CITY OF CODY
PLANNING, ZONING AND ADJUSTMENT BOARD
TUESDAY, JULY 10, 2012
CITY HALL COUNCIL CHAMBERS @ 12:00 NOON

**CITY OF CODY
PLANNING, ZONING AND ADJUSTMENT BOARD
STAFF REPORT**

MEETING DATE:	JULY 10, 2012	TYPE OF ACTION NEEDED	
AGENDA ITEM:		P&Z BOARD APPROVAL:	X
SUBJECT:	TCT WEST CORPORATE HEADQUARTERS SITE PLAN REVIEW, SPR 2012-28	RECOMMENDATION TO COUNCIL:	
PREPARED BY:	TODD STOWELL, CITY PLANNER	DISCUSSION ONLY:

MEETING DATE:	JULY 10, 2012	TYPE OF ACTION NEEDED	
AGENDA ITEM:		P&Z BOARD APPROVAL:	X
SUBJECT:	SITE PLAN REVIEW: WYOMING HOME AND RANCH RETAIL FACILITY. SPR 2012-27	RECOMMENDATION TO COUNCIL:	
PREPARED BY:	TODD STOWELL, CITY PLANNER	DISCUSSION ONLY:

1 SITE PLAN
AS1.1 SCALE: 1"=20'

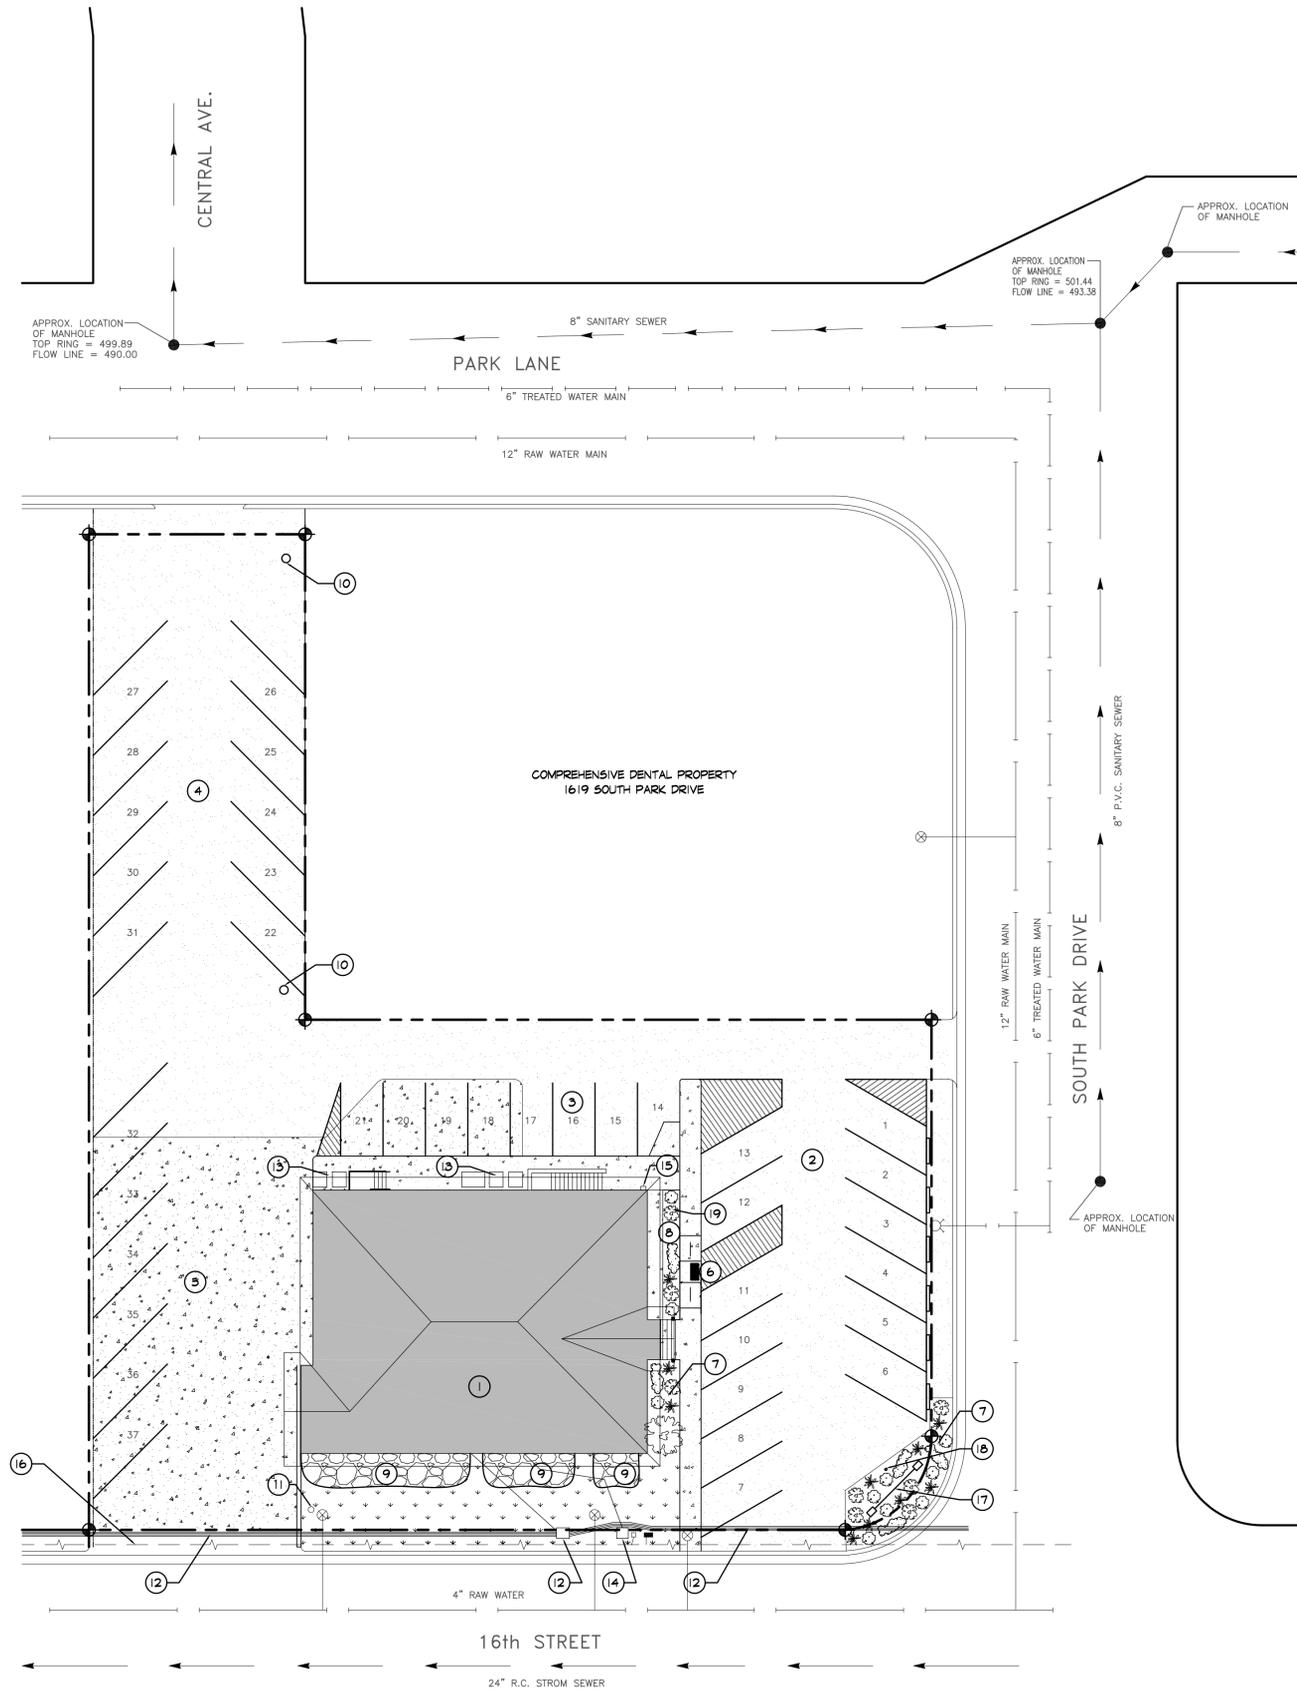
All parking areas are proposed to be re-striped. Removal of the elevated drive-thru lanes and some concrete from the east side of the building will allow additional parking.

There are some concerns with how some of the parking spaces and their backup areas are configured. Of most concern are the 90-degree spaces to the east of the building, in that they only have about 14 feet of backup area, where 24 feet is required. According to our calculations, 35-degree angled parking could work in this area, but only about four spaces will fit, as opposed to the eight shown.

Also the parking in Area 2 is proposed at 60-degrees, yet based on parking tables it appears that 50-degree parking is the most angled design that will provide sufficient backup area for these spaces. No spaces need be lost by this change.

The two proposed ADA parking spaces shown are required, and need to be installed so that one stall is van-accessible (11' wide), plus a 5' wide access aisle.

Although not noted on the proposal, staff has noted that the ADA access ramp that is proposed to be retained, which runs along the front of the building, needs repair/replacement. It appears to have sunk, creating an unacceptable cross slope. Also, the railing may need to be altered, depending on how the ramp is fixed—currently the rail is too far from the ramp, which would allow the wheel of a wheelchair to fall off the ramp. The applicant will need to work with the building official on this matter.

1. That the applicant submit a new site plan (Sheet AS1.1) with modified parking layouts that strictly comply with the dimensional standards recommended in the staff report, or other parking layouts demonstrated to provide sufficient backing and maneuvering area.
2. The ADA ramp and railing next to the front of the building must be repaired or replaced as needed to meet applicable code requirements.
3. Sidewalk shall be extended to the southwest area of the site, and an ADA ramp provided.
4. The project must otherwise comply with the submitted site plan and applicable building, fire, and electrical codes. A building permit application is required.

PROPANE STATION DETAIL

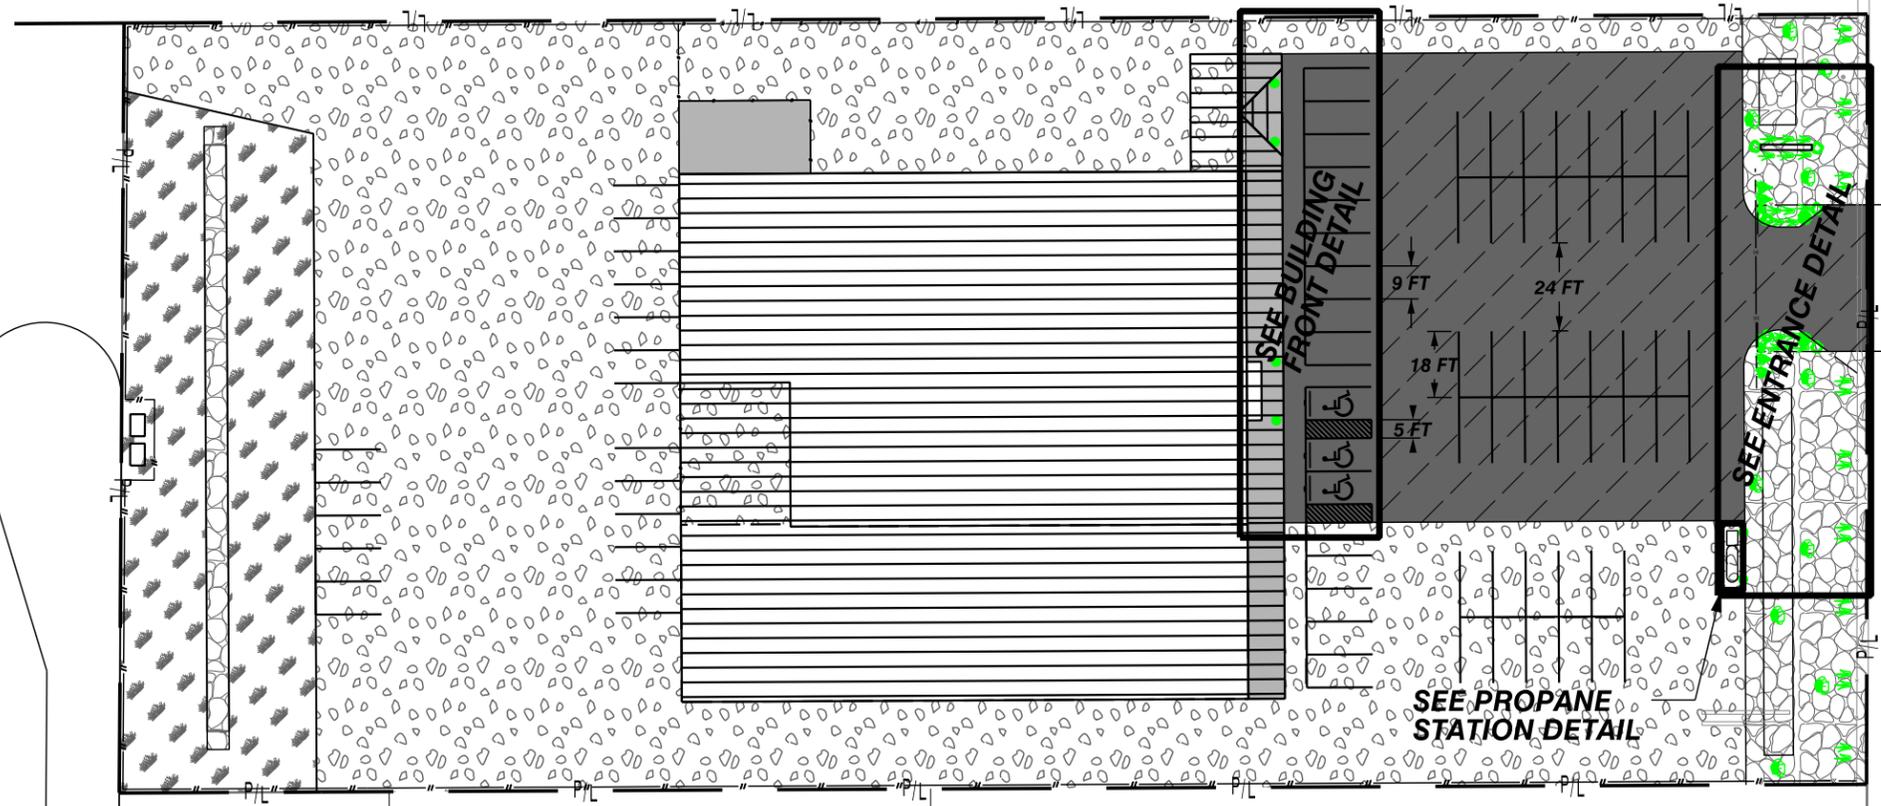
Propane Station: Shown on the landscape plan (Sheet 3 of 3). Current standards require 4" diameter steel, concrete-filled bollards, instead of 3" steel bollards, and they are to be located three feet or more from the propane container. The location/separation of the propane tank from property lines and Big Horn Avenue meets code, provided the tank is no more than 2,000 gallons in size.

4. The ADA parking spaces shall comply with the adopted dimensional requirements.
5. The propane tank size, location, and protection system (bollards) shall comply with applicable codes. The propane station detail on sheet 3 does not meet applicable code.

FREE STANDING SIGN
FRONT / SIDE ELEVATION

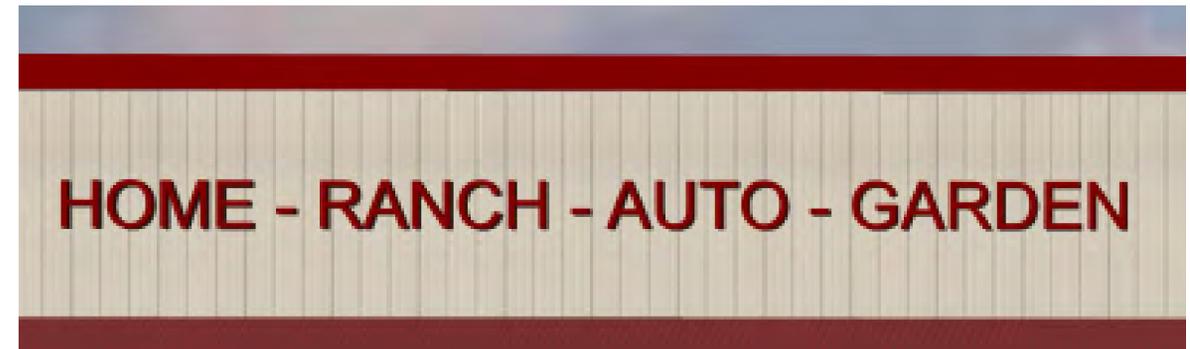
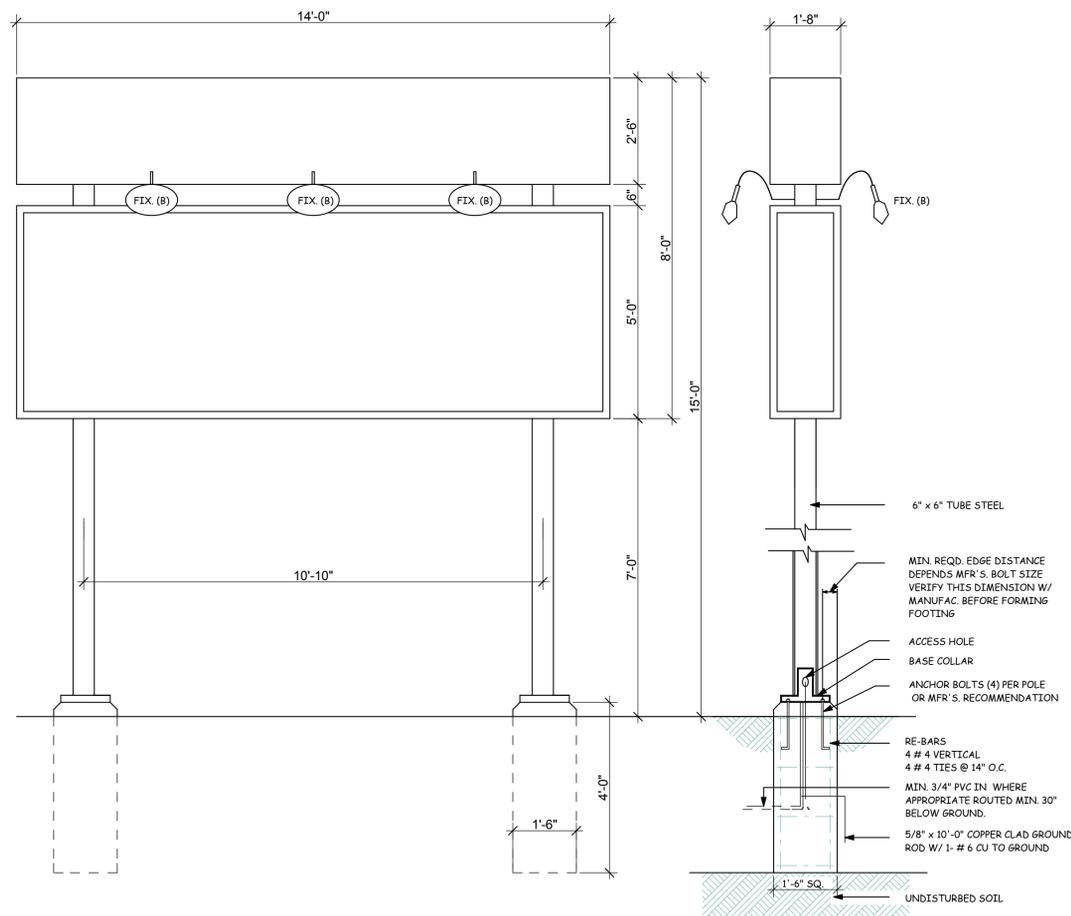
Signage design, sizes, and placement is shown on Sheet A4.0. A total of 285.25 square feet of wall signage and 210 square feet of free-standing signage are proposed, for a total of 495.25 square feet. This amount is allowed in the D-3 zone. The proposed

height of the freestanding sign is 15 feet, which complies with the maximum height requirements. The sign footings appear to be undersized, but that will be reviewed more fully with the building permit for the sign.

The upper portion of the freestanding sign is an electronic message board. It measures 2'6" by 14'. The electronic message board will need to comply with 10-15-3(B)(10) City of Cody Code, which among other things sets maximum illumination levels and requires automatic dimming at night. Automatic dimming is an optional feature on some LED signs, so the applicant is advised to review the requirements and verify all necessary options are included in the sign order. These requirements will be verified through the building permit application for the sign.

6. Label the curb stop in the water line on the Site/Utility Plan (Sheet 1 of 3).
7. The sign footings must be designed by an engineer.
8. The electronic message board must comply with 10-15-3(B)(10) of the City of Cody Code.
